V2500-A1/A5/D5 SERIES PROPULSION SYSTEMS SERVICE BULLETIN

This document transmits the Initial Issue of Service Bulletin EV2500-72-0462

ENGINE – LP COMPRESSOR – INTRODUCTION OF A REVISED HYDRAULIC SEAL AND A REVISED NO.2 BEARING OIL JET

Before and after alteration of Hydraulic Seal
Figure 1

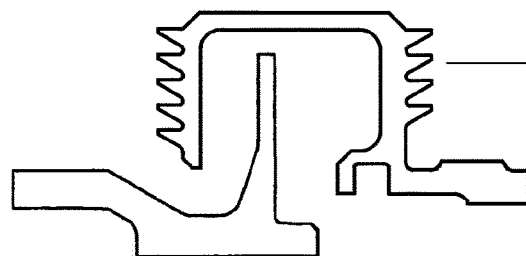
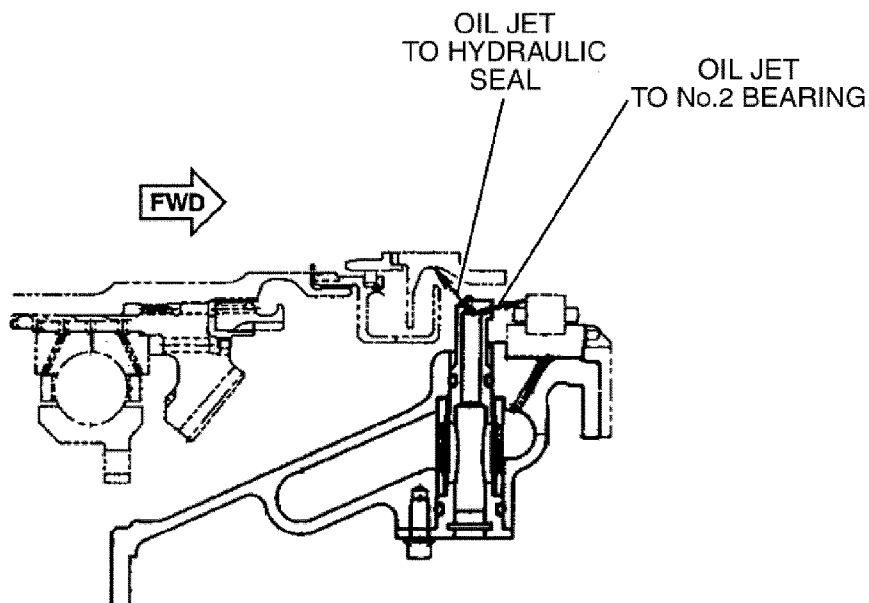
This Service Bulletin introduces cooling fins on the Hydraulic Seal Assembly to increase heat rejection, and enlarges diameter of the hole on the No.2 Bearing Oil Jet to increase oil flow. These redesigns prevent oil carbonization in the Hydraulic Seal.

- (a) The Hydraulic Seal Assembly is revised to add cooling fins to improve heat radiation. Refer to Figure 1 and 5.
- (b) The No.2 Bearing Oil Jet is revised to enlarge oil hole to increase oil flow to the Hydraulic Seal. Refer to Figure 2 and 6.

Before and after alteration of No.2 Bearing Oil Jet
Figure 2

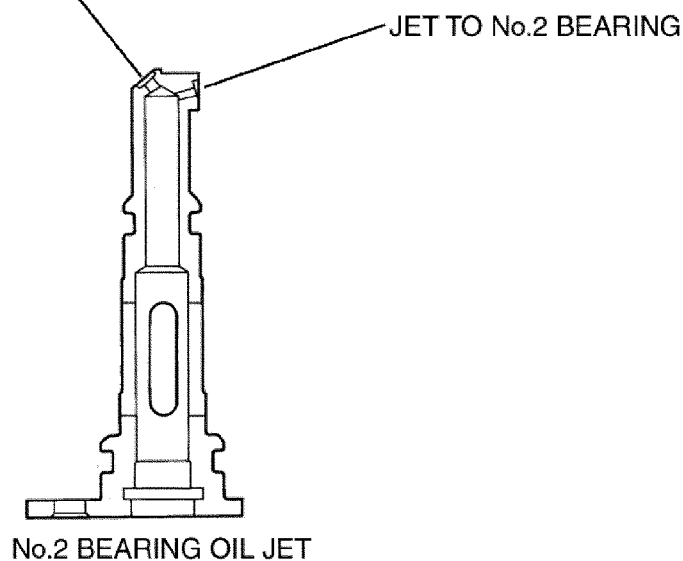
JET TO HYDRAULIC SEAL
OIL FLOW
BEFORE ALTERATION: 2.7 TO 2.9 (PPM)
AFTER ALTERATION: 5.5 TO 5.7 (PPM)

Family Tree - Seal, A/O Hydraulic (72-32-19, Fig 01 Item 100)
Figure 3 (Sheet 1 of 2)

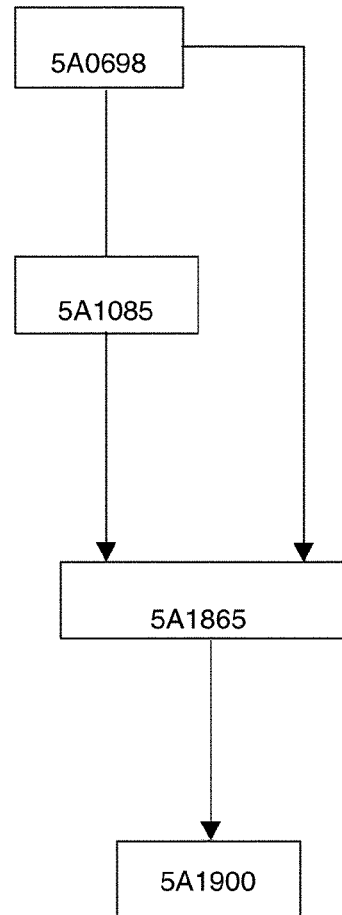
V2500-ENG-72-0462
LP COMPRESSOR -INTRODUCTION
OF A REVISED HYDRAULIC SEAL
AND A REVISED No.2 BEARING OIL
JET - CATEGORY 6

Family Tree - Oil Jet, A/O No.2 Bearing(72-32-17, Fig 01 Item 700)
Figure 4 (Sheet 2 of 2)

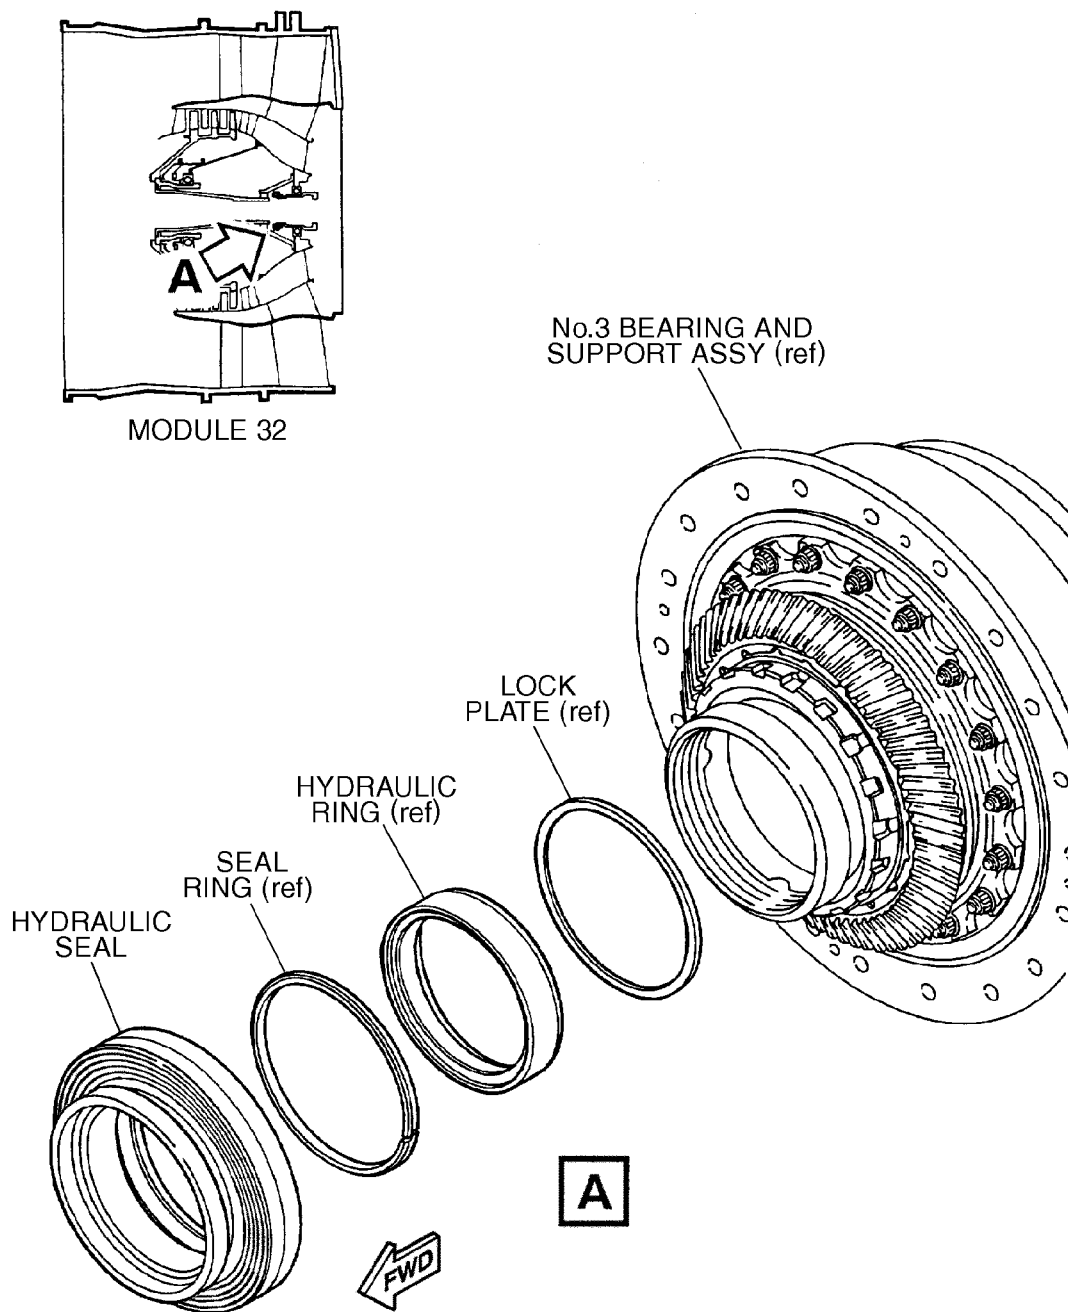
V2500-ENG-72-0462
LP COMPRESSOR - INTRODUCTION
OF A REVISED HYDRAULIC SEAL
AND A REVISED No.2 BEARING OIL
JET - CATEGORY 6

Location of Hydraulic Seal
Figure 5

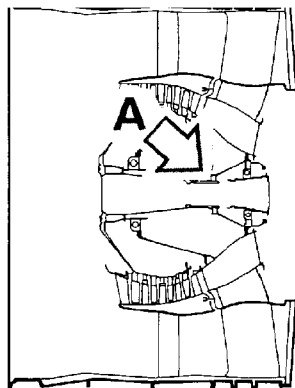
- (3) Assemble the Hydraulic Ring and Seal Ring into the Hydraulic Seal Assembly. Refer to Figure 5 and EM (E-V2500-1IA) 72-32-10, Assembly, Config-01 or Config-02 or EM (E-V2500-3IA) Assembly, except:

- (a) Use the new 5A1900 Hydraulic Seal Assembly (72-32-19, 01-100).

Location of No.2 Bearing Oil Jet
Figure 6

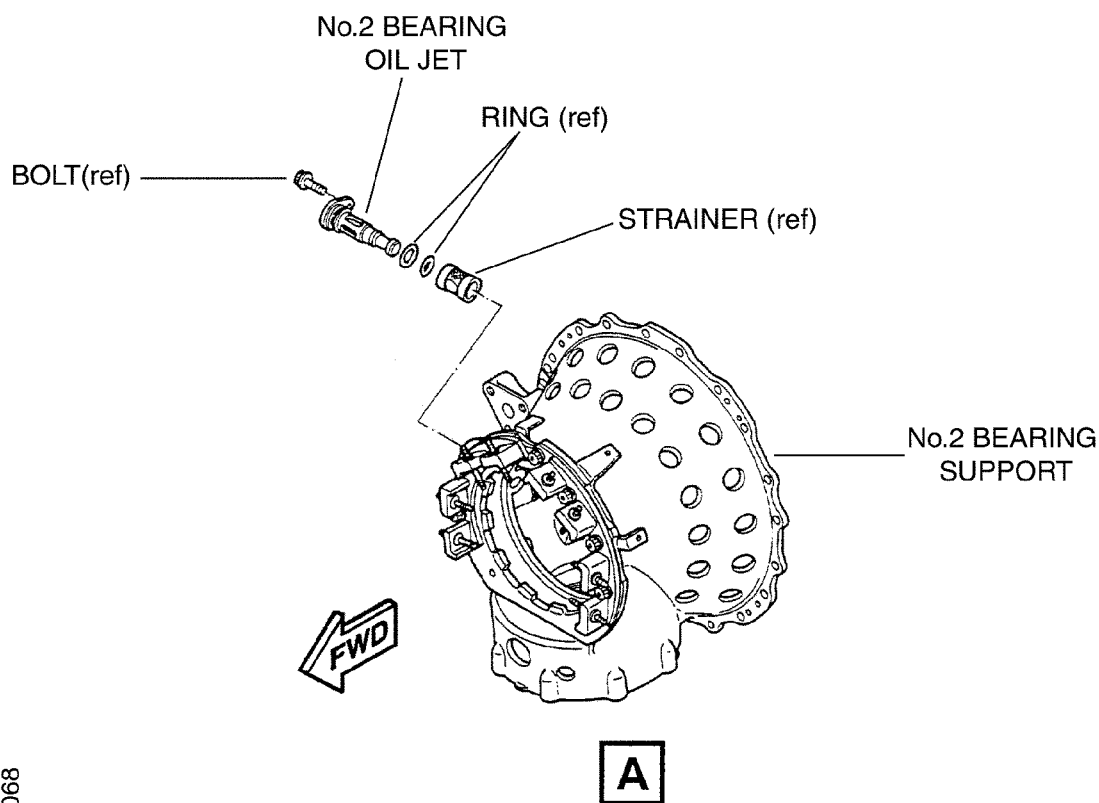
- (2) Install the Oil Jet. Refer to Figure 6 and EM (E-V2500-1IA) 72-32-10, Assembly, Config-01 or Config-02 or EM (E-V2500-3IA) Assembly, except:

- (a) Use the new 5R0293 Oil Jet (72-32-17, 01-700).

Install the Hydraulic Seal Assembly on to the HP Compressor Front Shaft
Figure 7

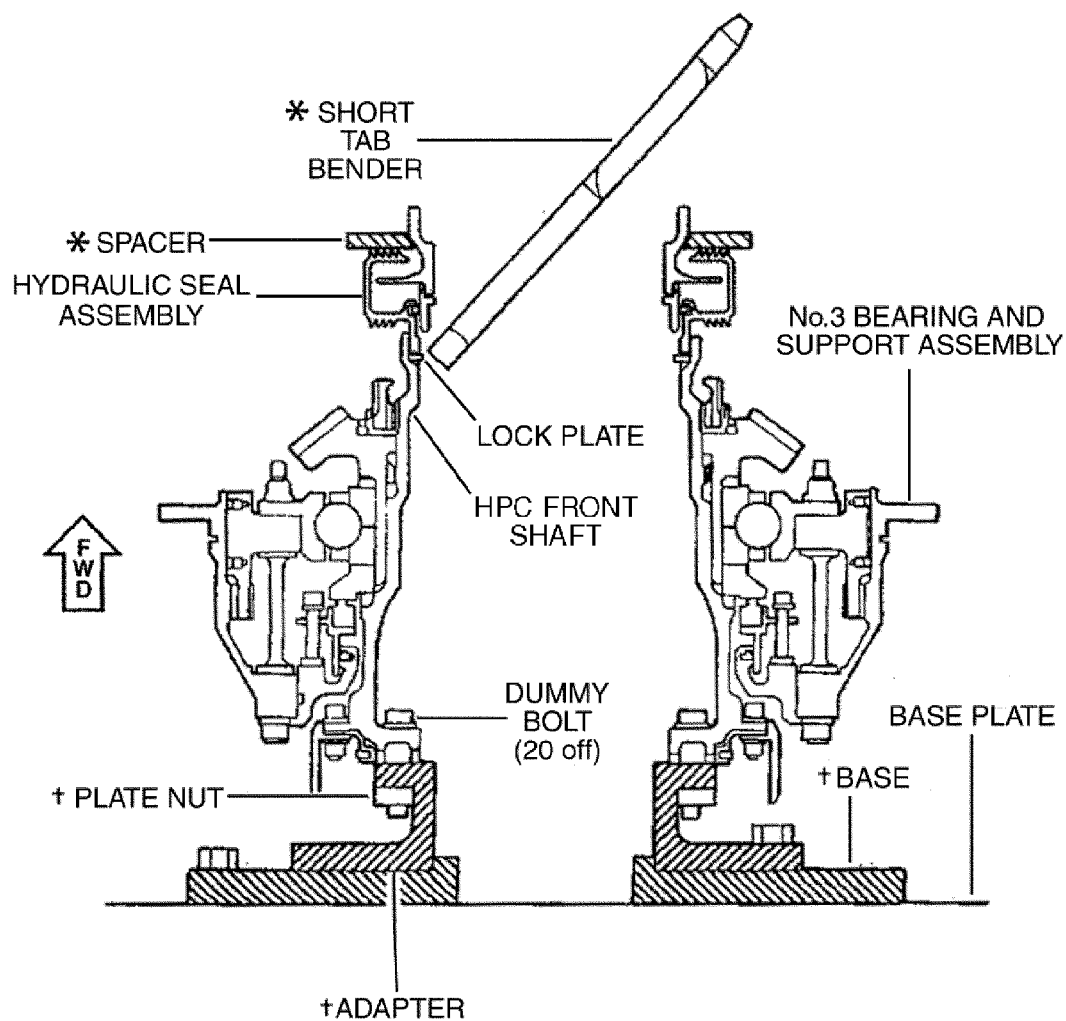
- (4) Install the Hydraulic Seal Assembly on to the No. 3 Bearing and Support Assembly. Refer to Figure 7, 8, 9 and EM (E-V2500-1IA) 72-32-10, Assembly, Config-01 or Config-02 or EM (E-V2500-3IA) Assembly, except:

- (a) Install IAE 1J12355 spanner wrench 1 off on to the Hydraulic Seal Assembly.

Crimp the Lock Plate in to the slots of the HP Compressor Front Shaft
Figure 8

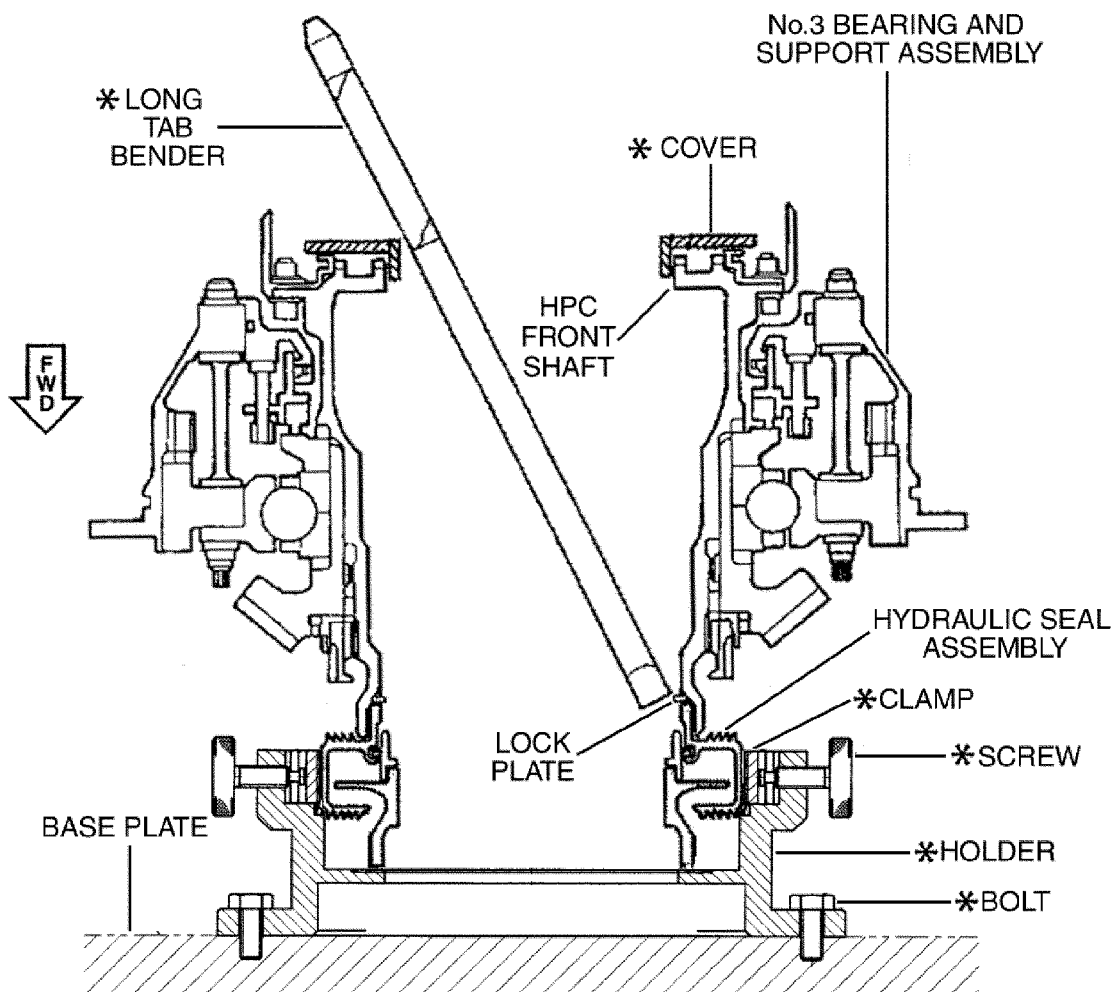
- (b) Crimp the lock plate into the slots of the HPC front shaft.

- (i) Use IAE 1J12381 tab bender 1 off.
